# Technical product information

<b>Topic</b>	Front and/or rear internal door trim panel - Poor retention between the trim panel and door
<b>Market area</b>	Bentley: worldwide (2WBE),China 796 VW Import Comp. Ltd (Vico), Beijing (6796)
<b>Brand</b>	Bentley
<b>Transaction No.</b>	2074995/1
<b>Level</b>	EH
<b>Status</b>	Approval
<b>Release date</b>

Front and/or rear internal door trim panel - Poor retention between the door trim panel trim clips and door panel tucker studs

Figure 1

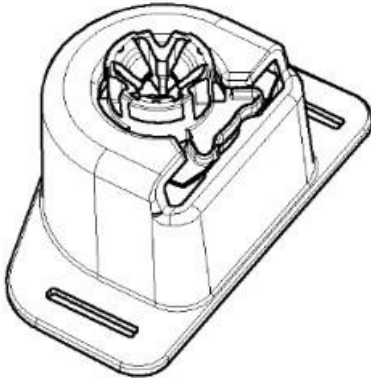
The door trim panel is retained to the door panel tucker studs with trim clips (Figure 1)

Figure 2

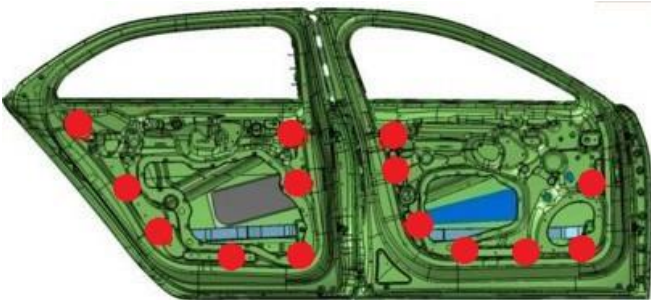
The door trim clips fit / secure onto the door panel tucker studs, the tucker studs are located as shown in Figures 2 and 3 (Depending on model)

- Flying Spur (front and rear doors) - Figure 2

All VIN's from SCBBK53S4PC010426 have the latest specification tucker studs fitted at the time of production. The new tucker studs have a more severe shaping to increase the pull off loads of the tucker clips irrespective of any coatings present

Figure 3

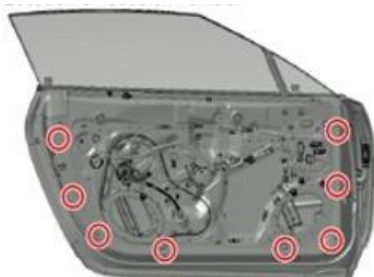
- Continental GT/C (Figure 3)
